Item Name: Strut

ENGINEERING CHANGE NOTICE NO.

DWG NO. 646.3500

DWG TITLE: STRUT

SHEET 2 IS:

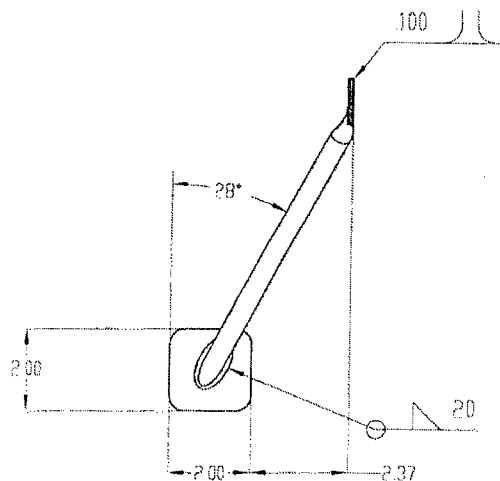
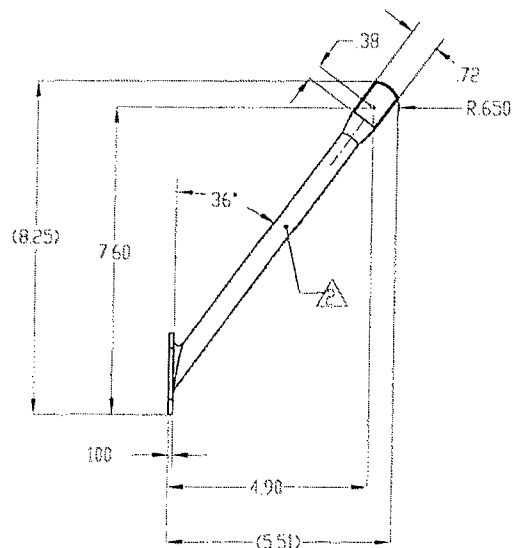
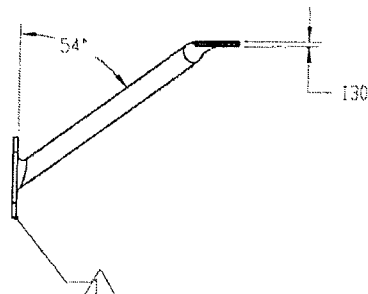
ENGINEERING CHANGE NOTICE NO.		02440		SHEET 1 OF 1	
DWG NO. 646.3500		REV: NC	PREPARED BY S. HUFF	DATE 06/08/09	EFFECT ON DWG ☐ INC. ☒ UNINC.
DWG TITLE:		STRUT			
APPROVED BY:	ENGR 	MFG 	QC 	EFF: CURRENT ORDER AND STOCK	
REASON: REVISED GEOMETRY TO ACCOMMODATE NEW EXISTING AIRCRAFT PROVISIONS

SHEET 2, IS:

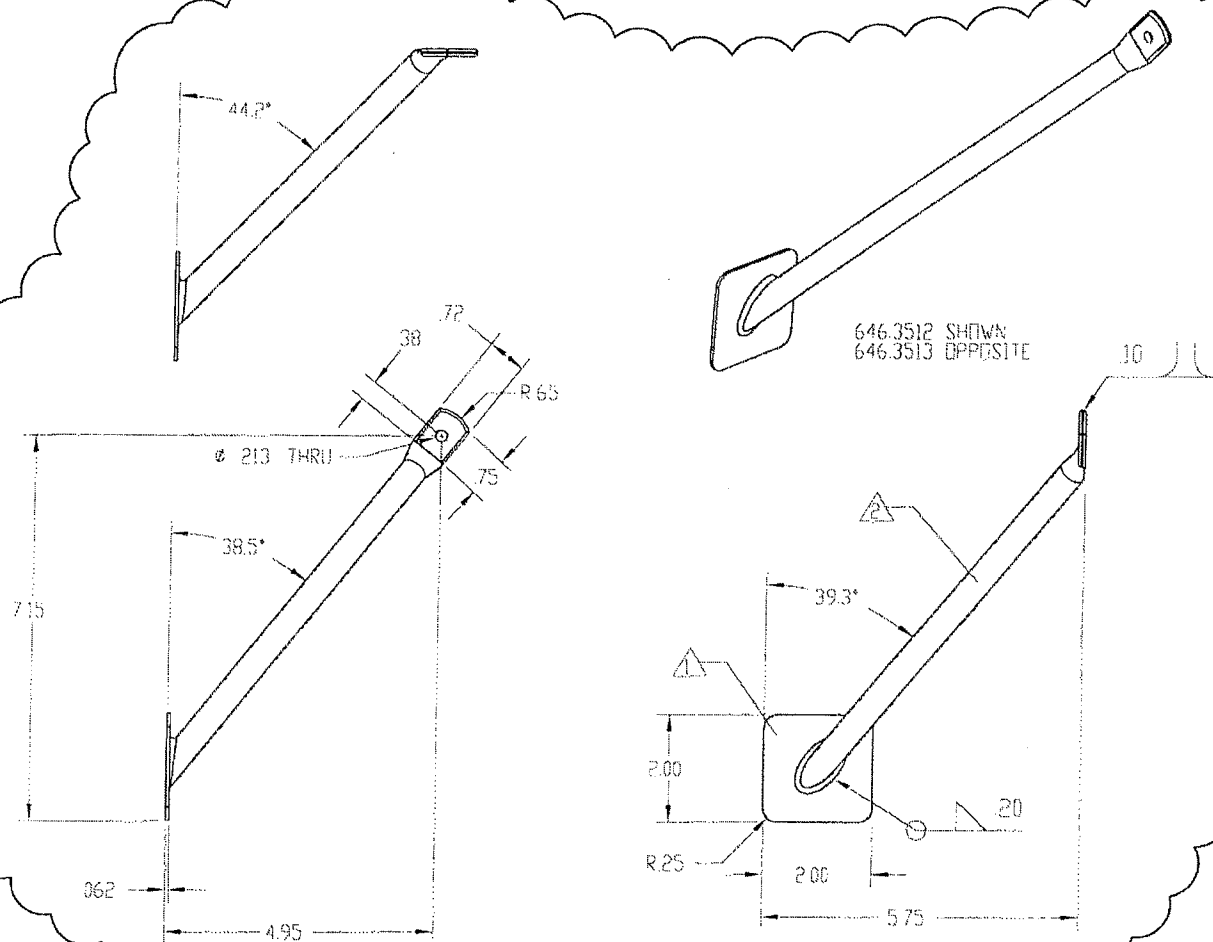
REASON: REVISED ANGLE OF 646.3512 & 646.3513 FOR BETTER FITMENT
